MARINO ENGINEERING ASSOCIATES, INC.

April 15, 2020

Re: Review of Brook Mine Application – Rounds 8 to 12

FIGURE 2 NEW PROPOSED MINE PLAN OF THE BROOK MINE SHOWING THE ADJACENT OLD WORKS

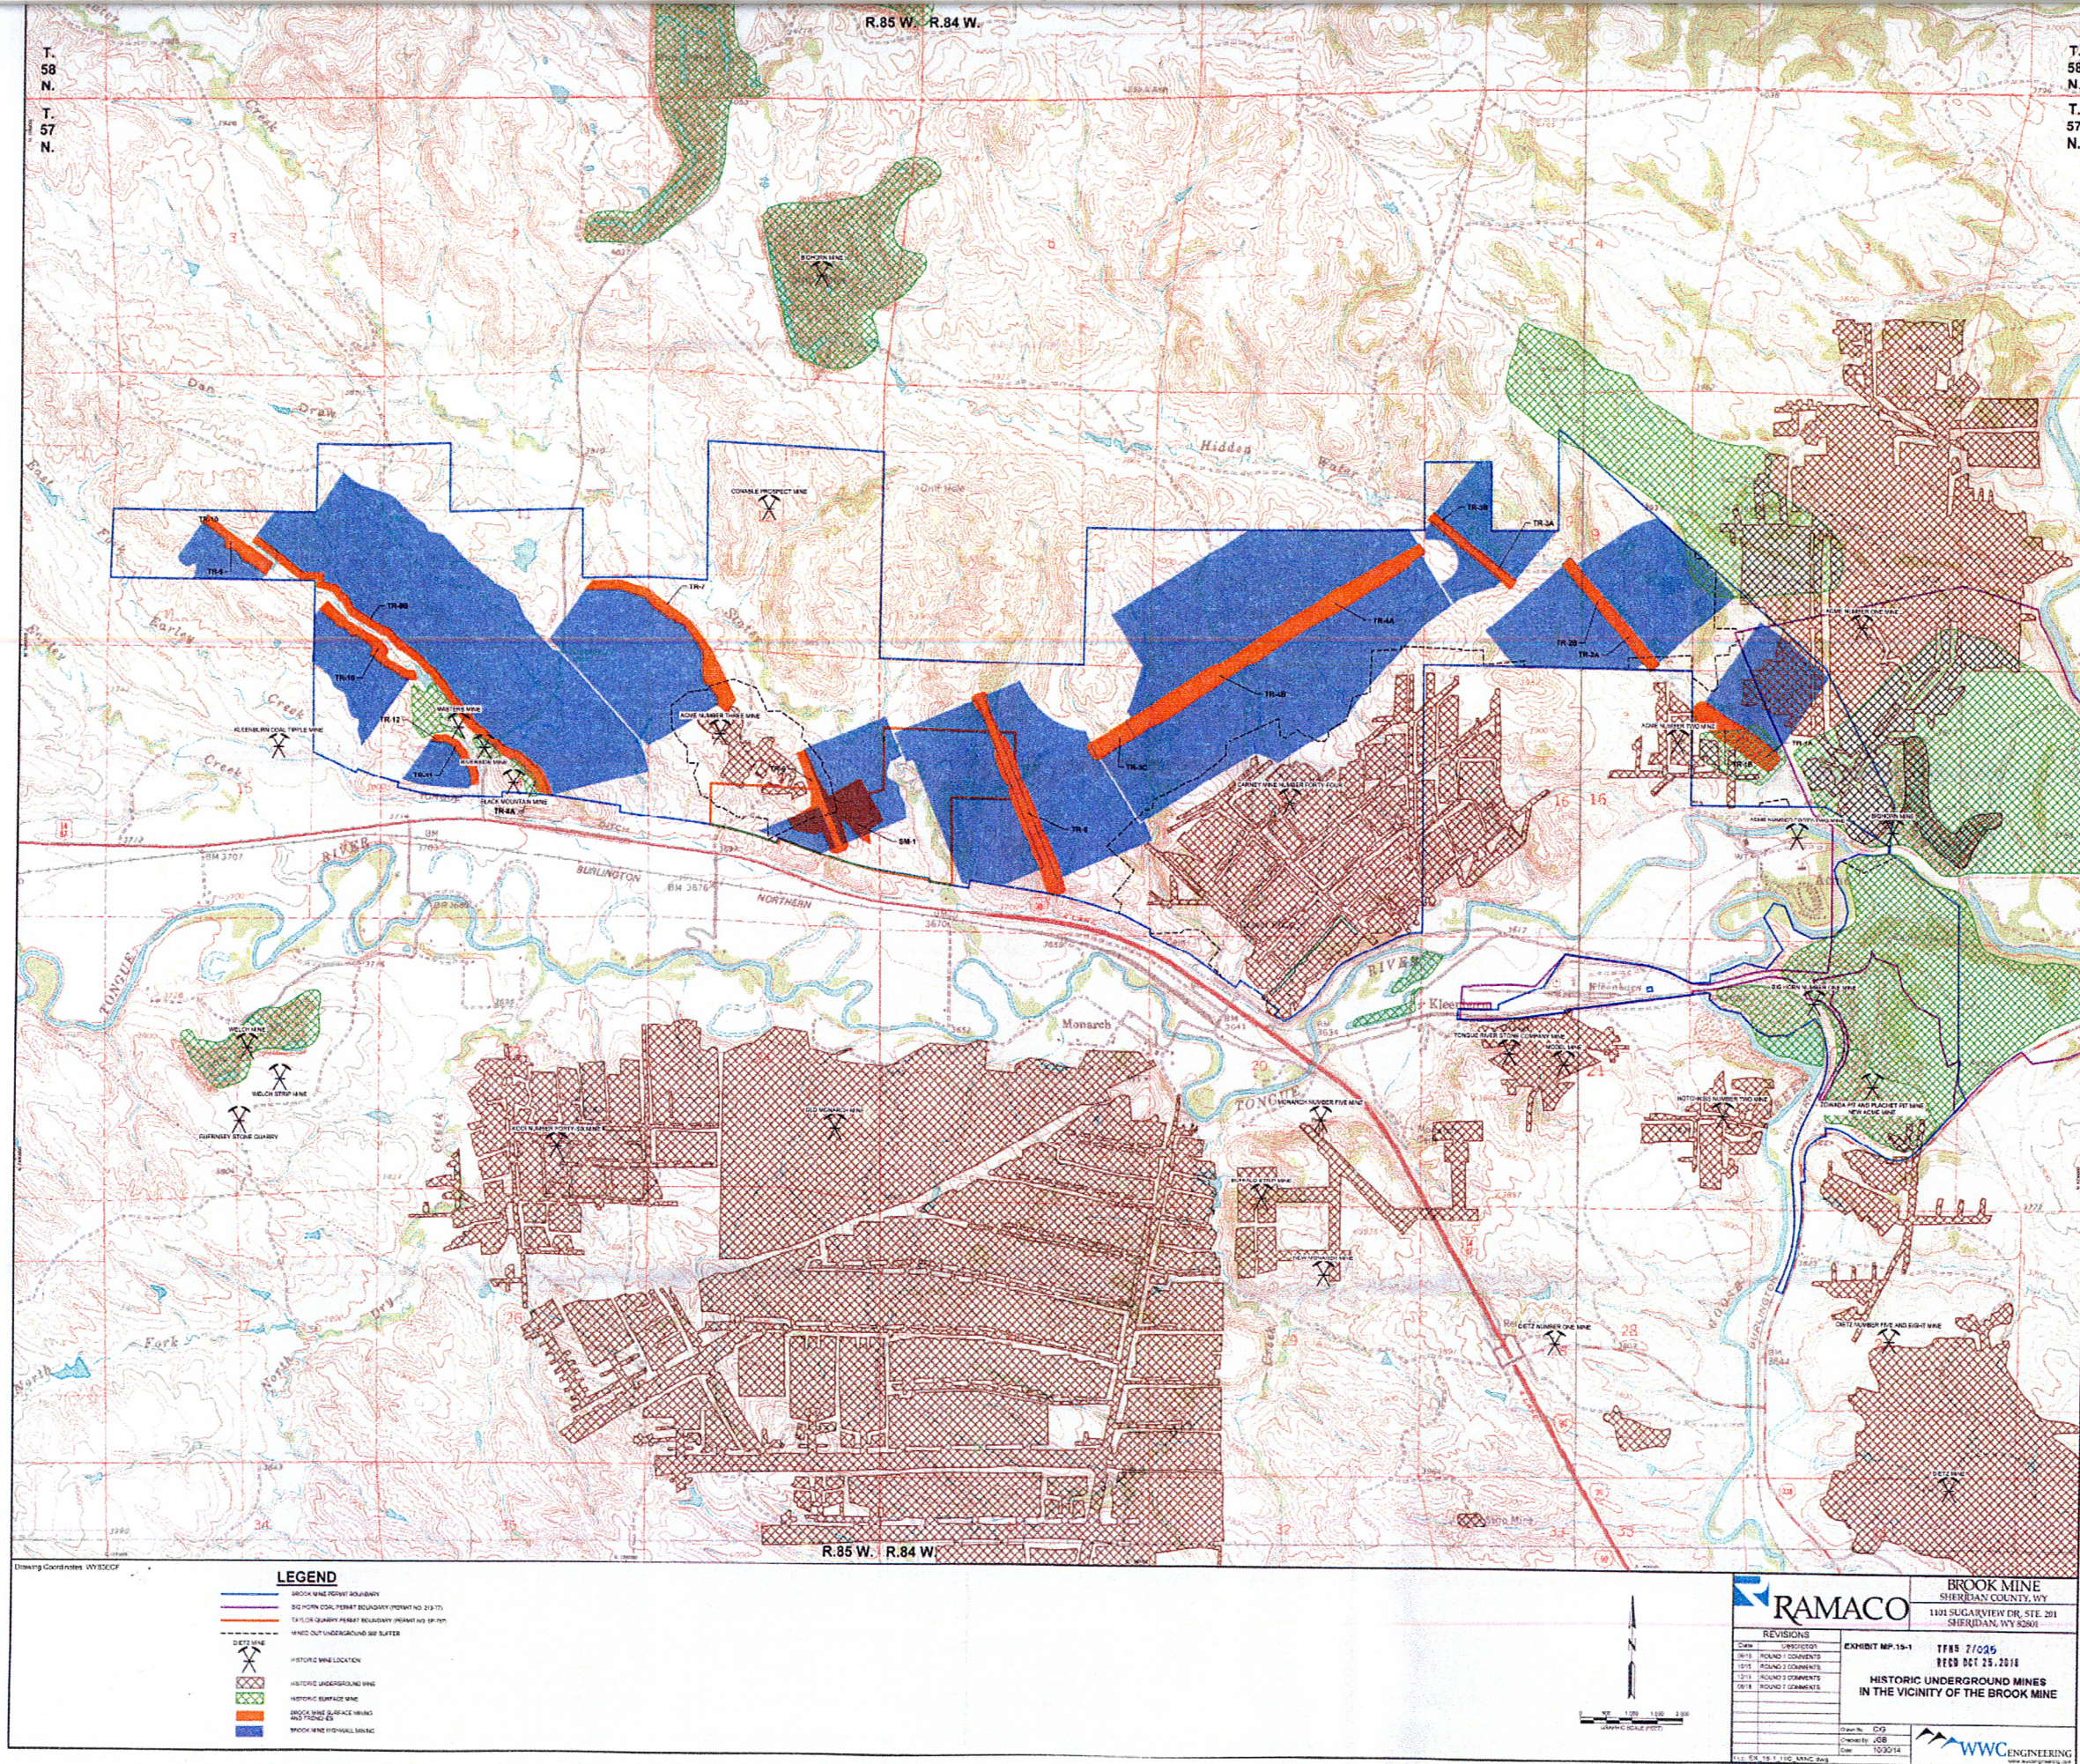
The new proposed HWM TR-1 area consists of only one block (in lieu Blocks 3 and 4 formerly TR-2, see MEA, 2017). The new mine plan is shown in Figure 2. Comparing Figure 4.3 (MEA, 2017) to Figure 2, it appears the changes in the mine plan only pertain to the old TR-1 and TR-2 areas. Consequently, the HWM areas which were Blocks 9 and 16 in Figure 4.3 still abut against old workings with minimum barrier coal of 0 to 70 ft. and consequently result in potentially flooding from the old workings to the south especially considering the likely inaccuracies of the mine map of the old works. Based on historical mapping, the floor depths in the minimum barrier areas are about 87 to 115 ft. in the new TR-4B, 5, and 7 areas. See Figure 2. Based on various empirical relationships on the minimum confirmed barrier thickness, this barrier should be at least about 55 to 110 ft. (Koehler and Tadolini, 1995), and therefore all areas (TR-4B, 5, and 7) would exceed the

FIGURE 3 SKETCHES OF THE THREE PRINCIPAL MODES OF FAILURE OF ROOM-AND-PILLAR MINE WORKINGS WHICH CAN RESULT IN SURFACE SUBSIDENCE

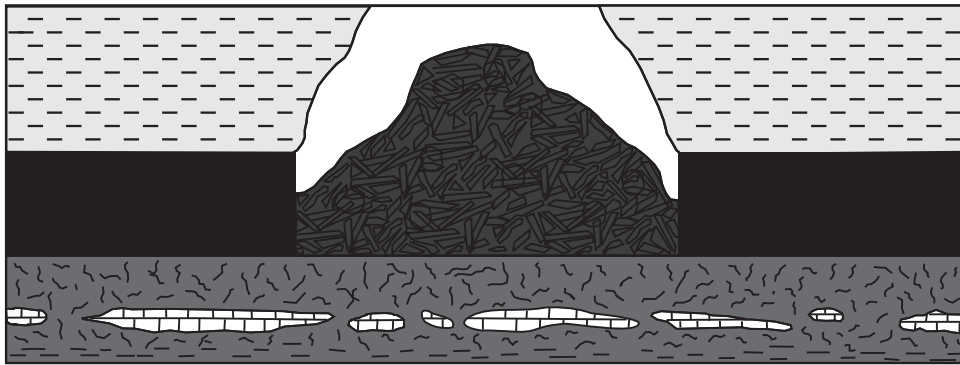
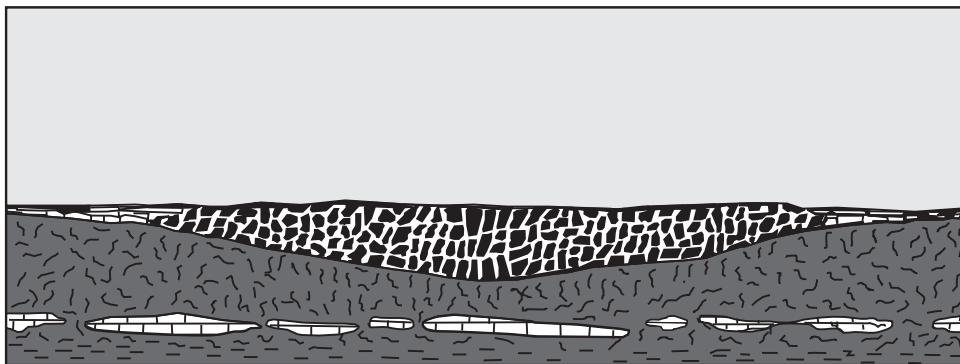
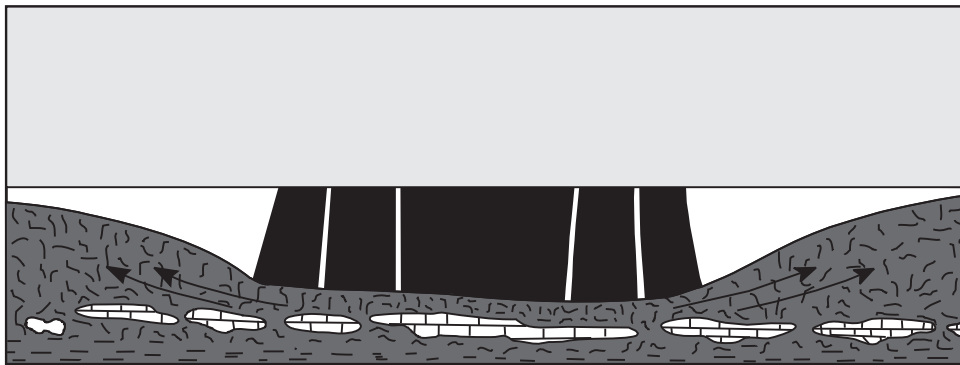
Below is the review of limited AAI mine design analyses against mine roof, pillar and floor failure based on the information available in the AAI report. See Figure 3.

Figure MP-6.2-4 Explanation of Variables in Equation MP-6.2-1 (Dyne, 1998)

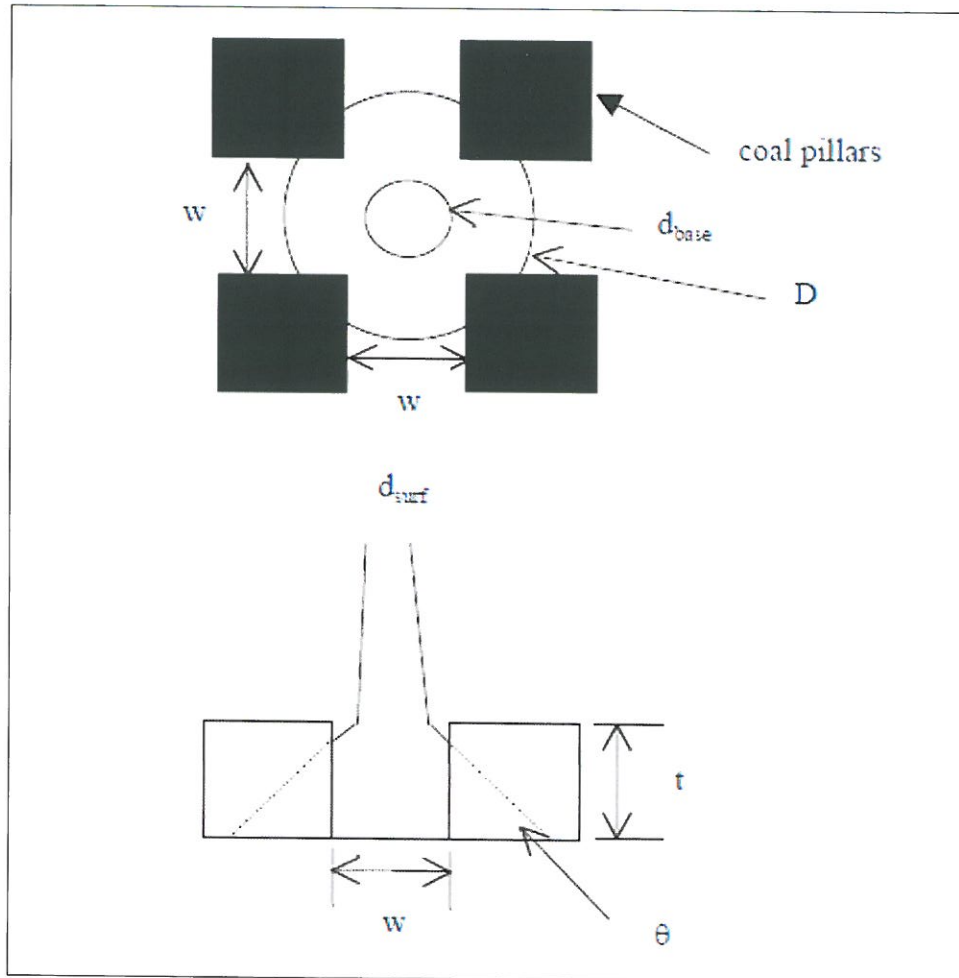
4. The method of “probability” used by AAI given above for sinkhole subsidence for HWM of the Carney seam in the TR-1 area is also in conflict with the methodology provided by Ramaco in the Subsidence Control Plan (SCP) for the overall application area. This methodology is discussed in detail in MEA, 2017. The methodology used by Ramaco recognizes the importance of other parameters in prediction of chimney subsidence which is ignored by the “probability” criteria used by AAI. Chimney prediction methodology (e.g., Piggott and Eynon, 1977, Garrad and Taylor, 1988, Whittaker and Reddish, 1989, and Dyne, 1998) typically considers at a minimum the bulking (volume expansion) from the caving of intact roof rock, the extraction height, width of intersecting mine openings and the repose angle or the spread of the caved material into mine openings. This was exemplified by Ramaco in Figure MP-6.2-4 (see Figure 4).

FIGURE 4.3 PLANNED TRENCH AND COAL BLOCK AREAS WITH FAULTS AND CROSS SECTION LINES

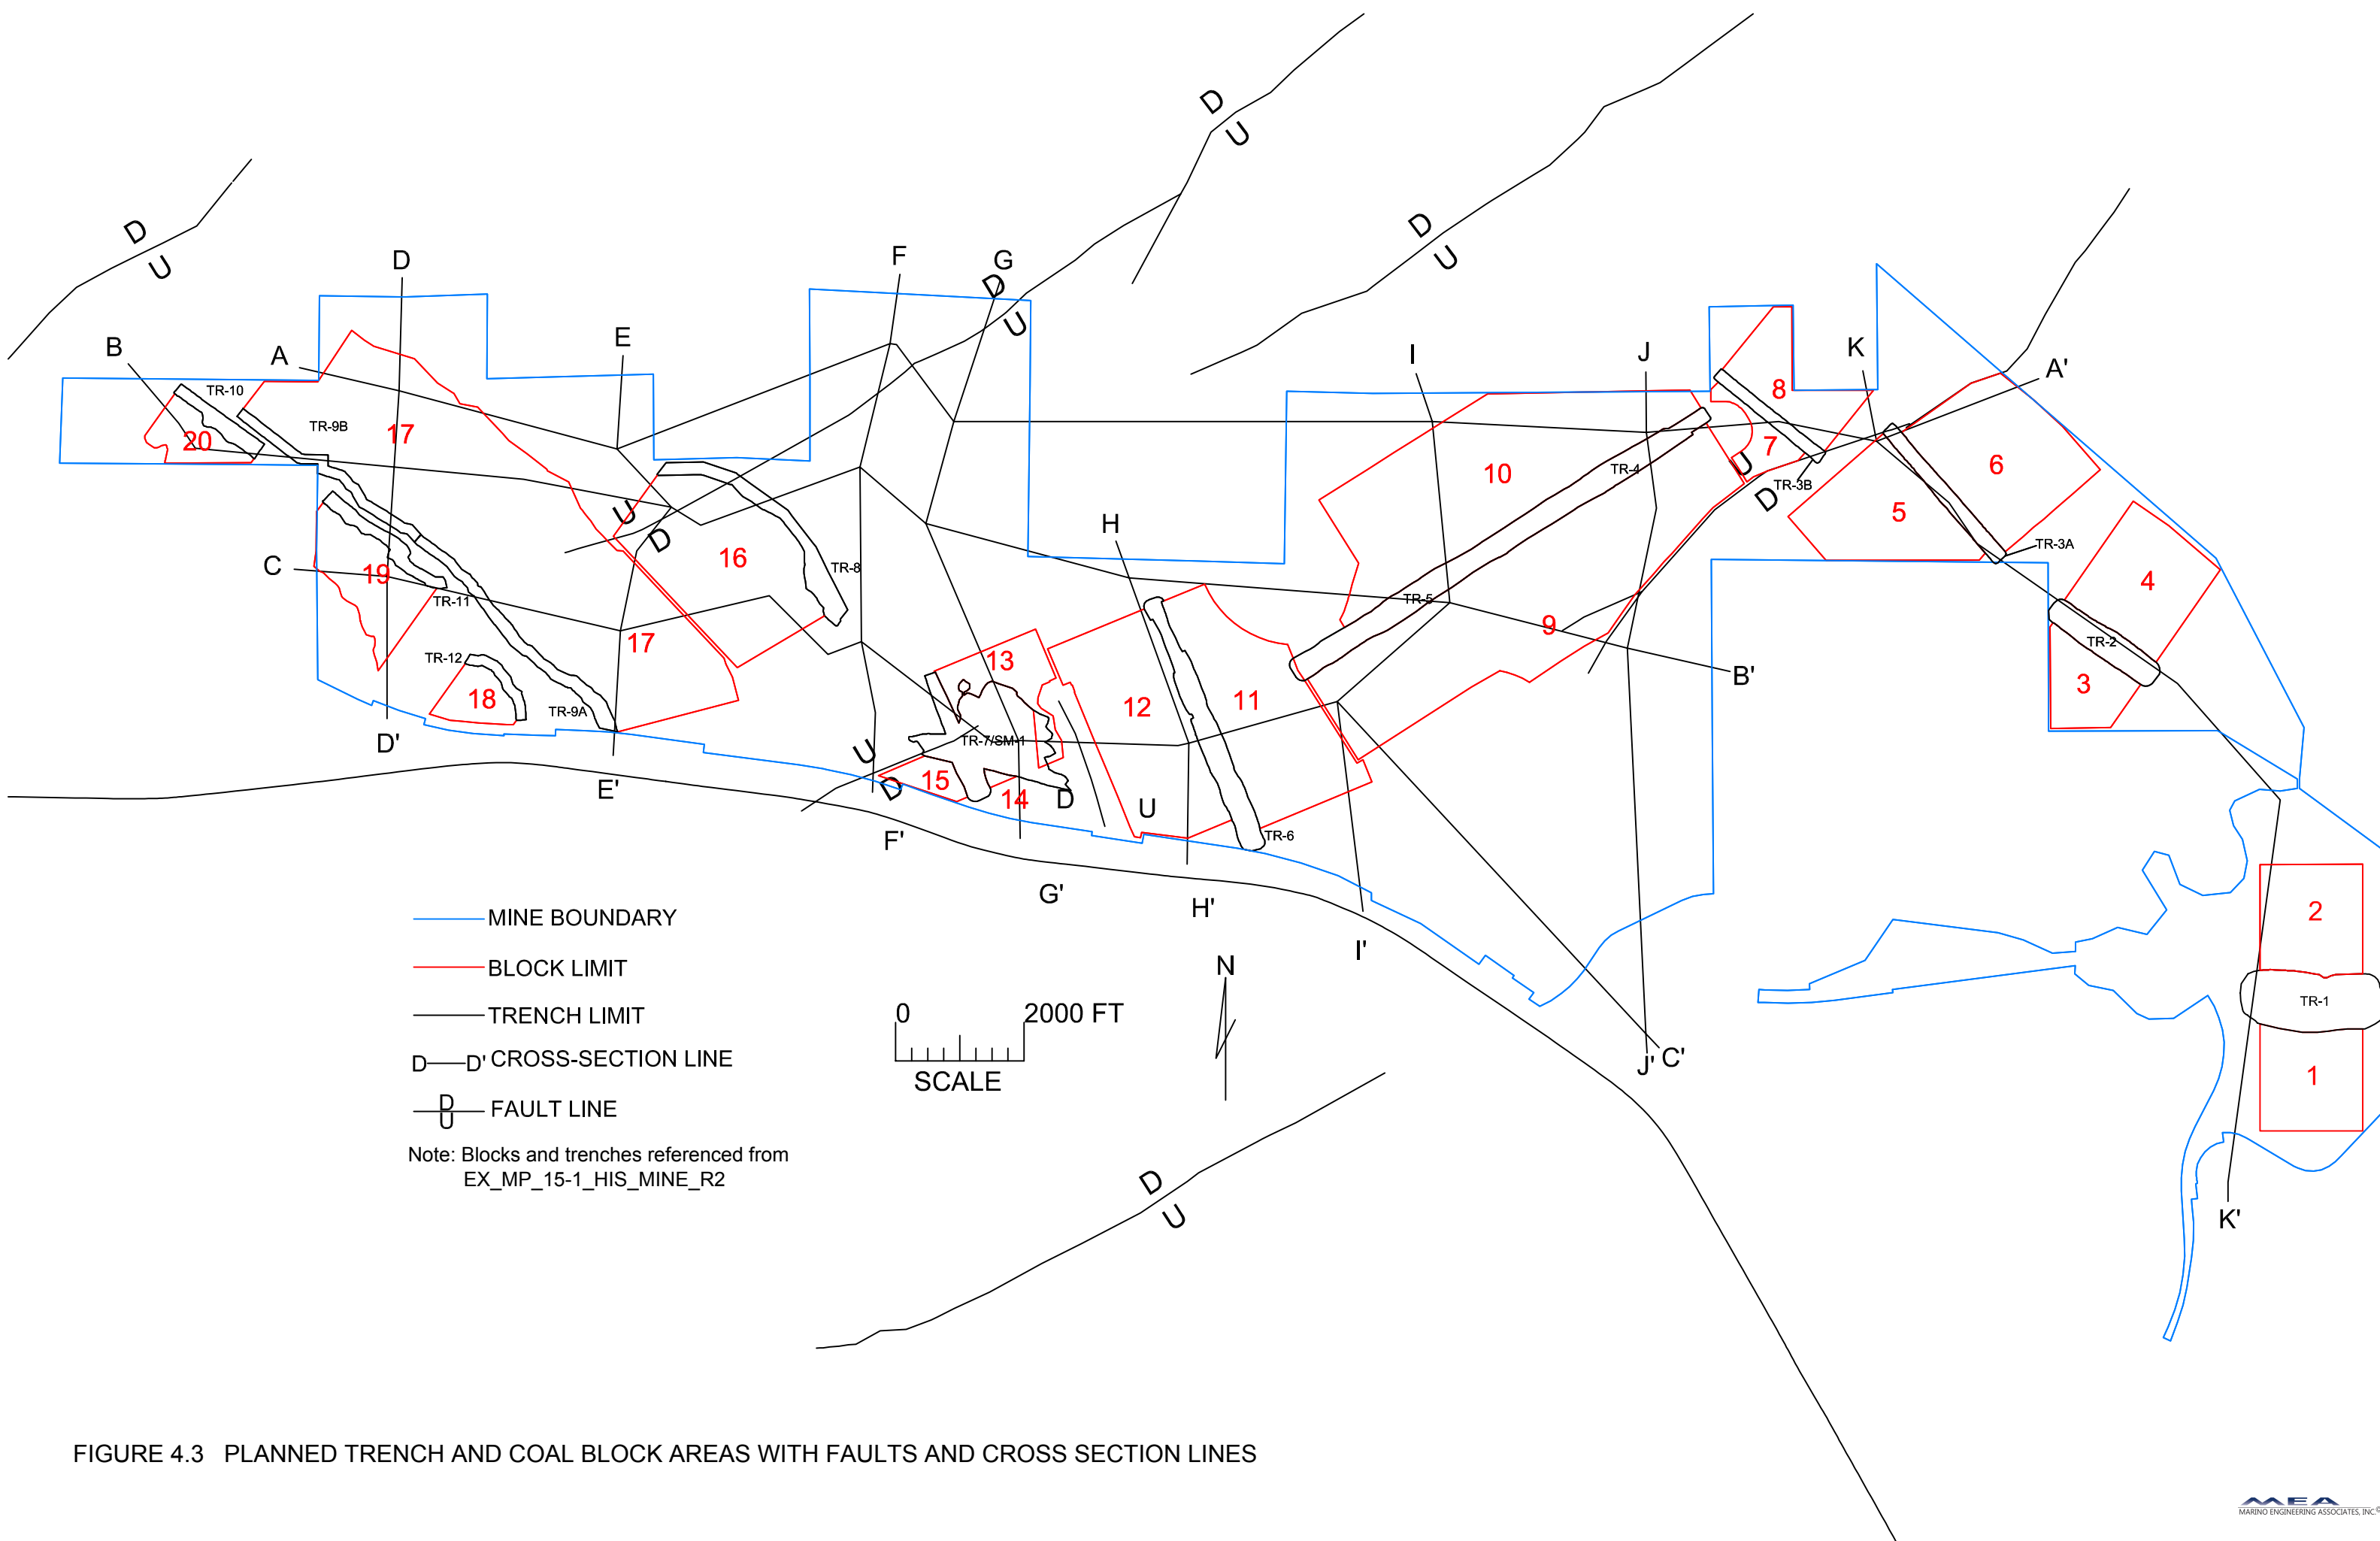
In order to better understand the ground conditions in the areas of proposed mining, the mining layout given in Figure 4.3 has been superimposed over the various isopach exhibits for the Carney and Masters seams provided in the mine application. These drawings are shown in Figures 4.5 to 4.12. Also, the mine block areas had been delineated on the various geologic cross-sections drawn by Ramaco across the site (see Figure 4.3). The modified cross-sections showing the mine block locations are shown in Figures 4.13 to 4.24. From this reported information, the Dietz, Monarch, Carney, and Masters related conditions per block have been summarized in Table 4.1.
